**AMERICAN FORK CITY  
NOTICE OF PUBLIC HEARING  
PLANNING COMMISSION REGULAR SESSION  
February 8<sup>th</sup>, 2023  
7:00 p.m.**

Review and action on a Site Plan application for the DBN Tax Project, located at 34 W 100 N, in the Central Commercial (CC-1) Zone.

# DBN TAX BUILDIGN SITE – 34 W 100 N, American Fork Utah

## RESPONSE TO CITY COMMENTS AS OF 15 NOV 2022

**DBN TAX**  
**SITE PLAN - 34 W 100 N**

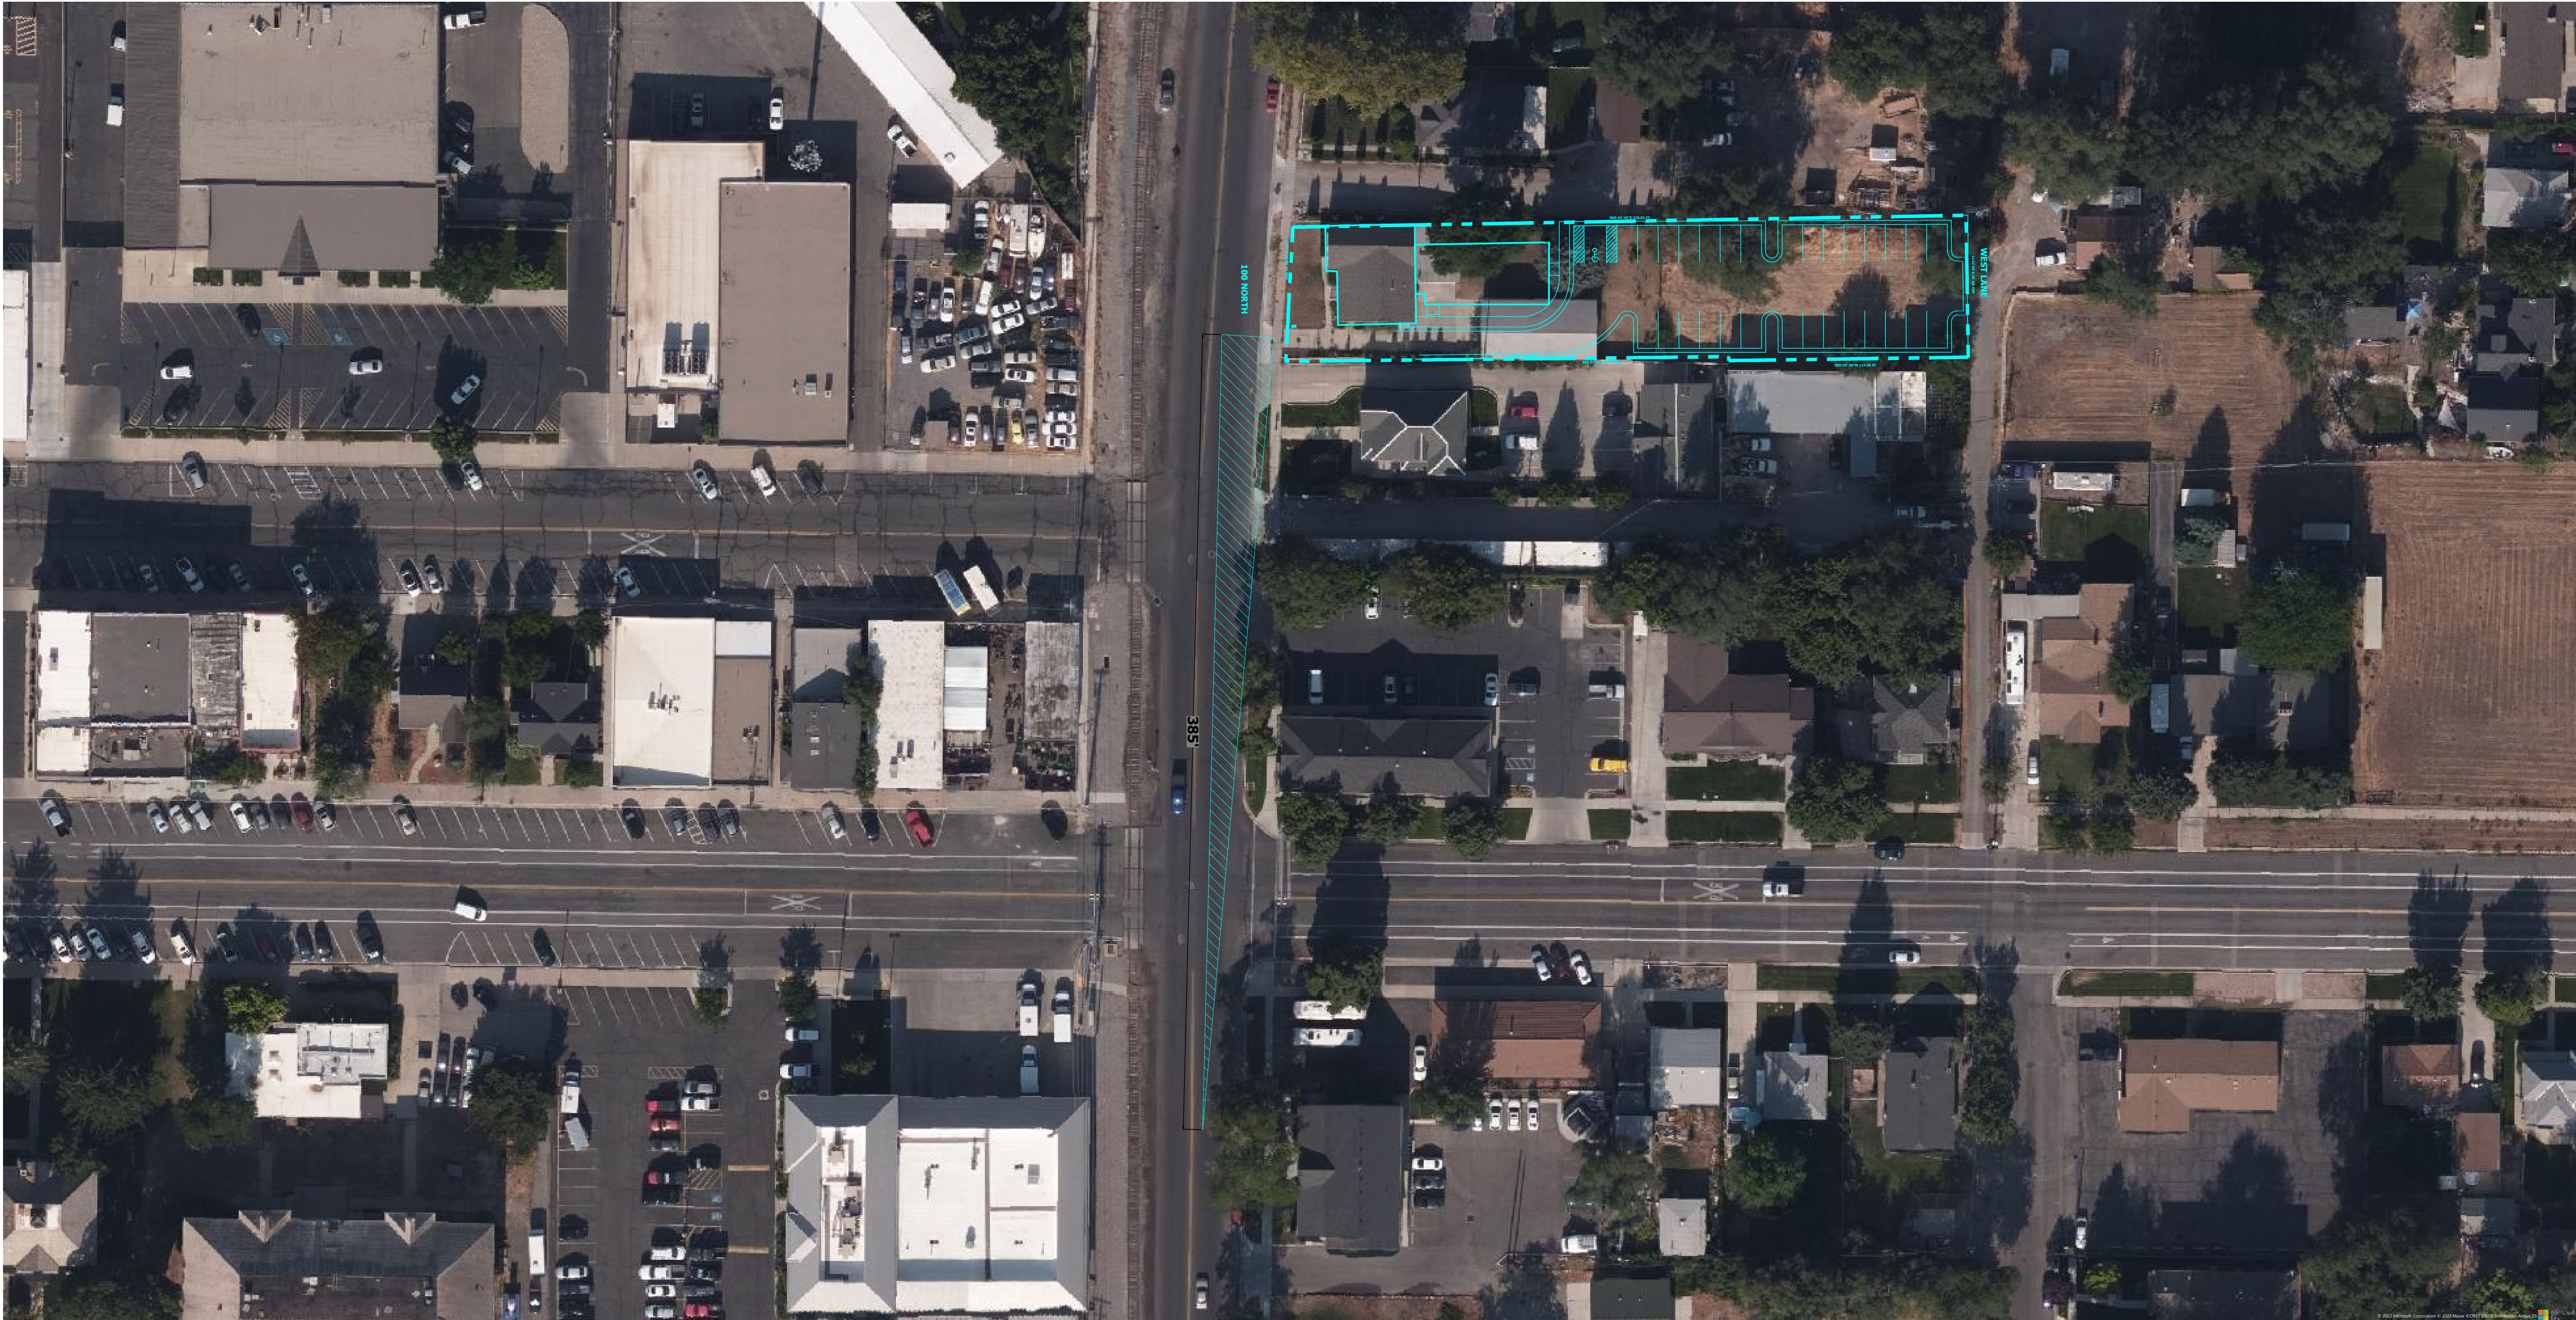
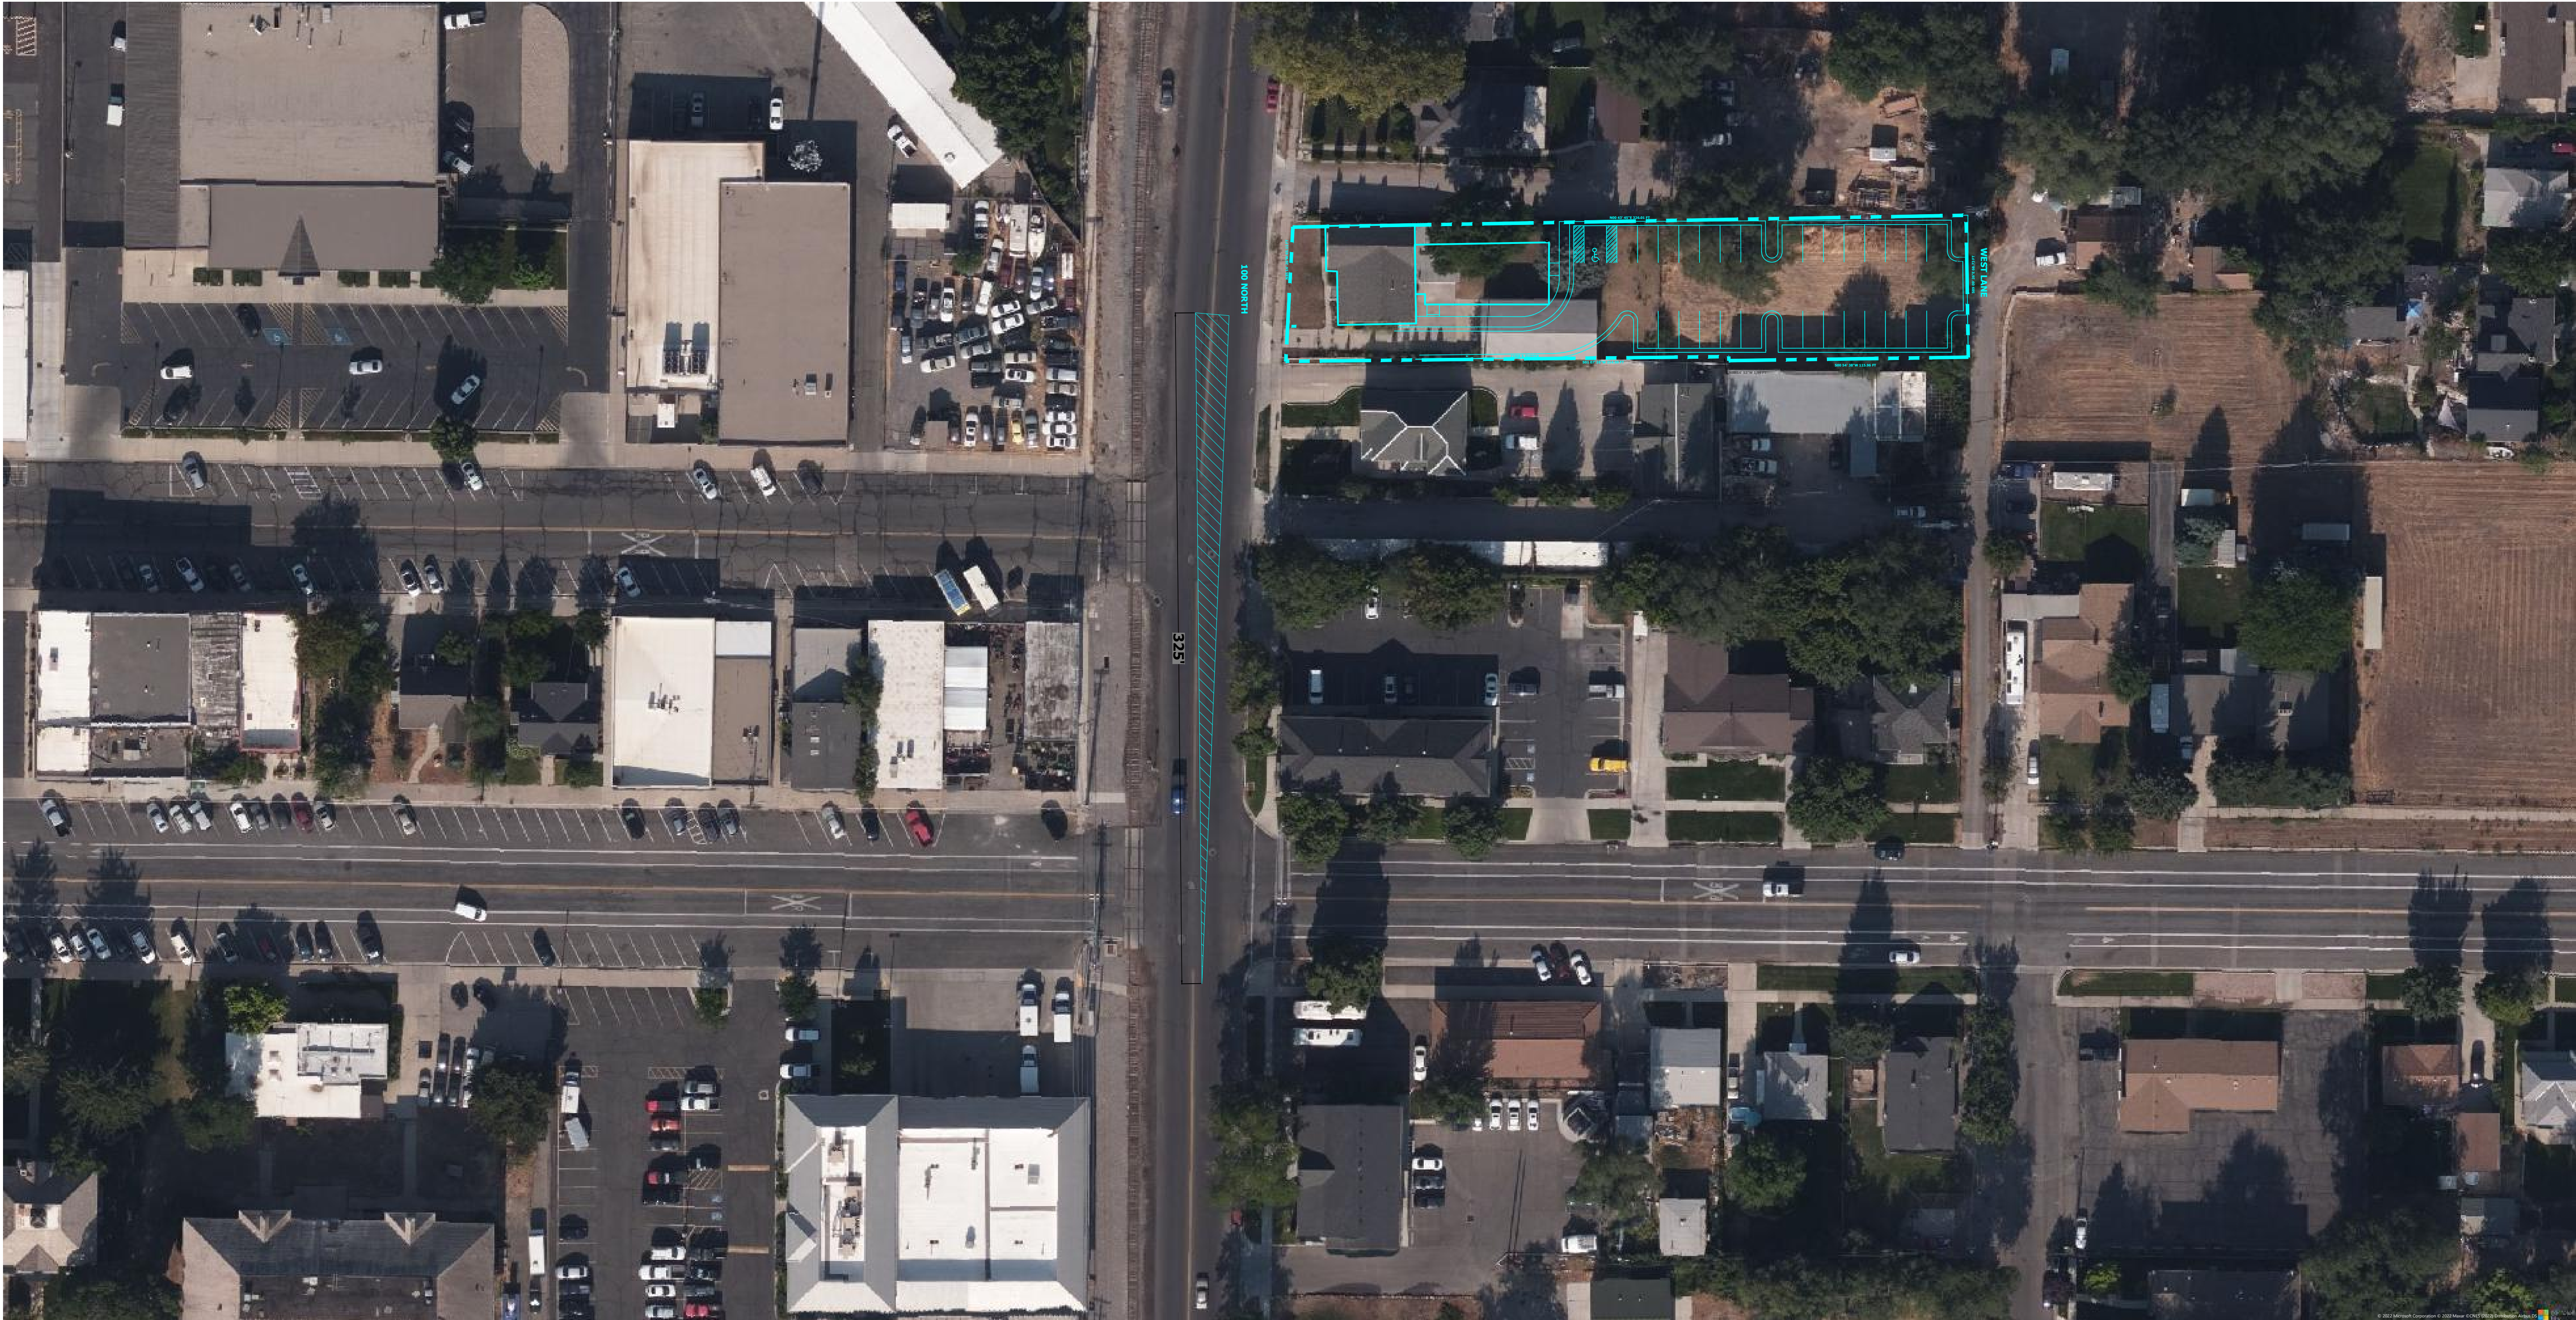
pls show in plan

need to show the grades

per city Engineer, If the overhead utility is being using, please remove the overhead line and reconnect to the existing buried utility near by the property.
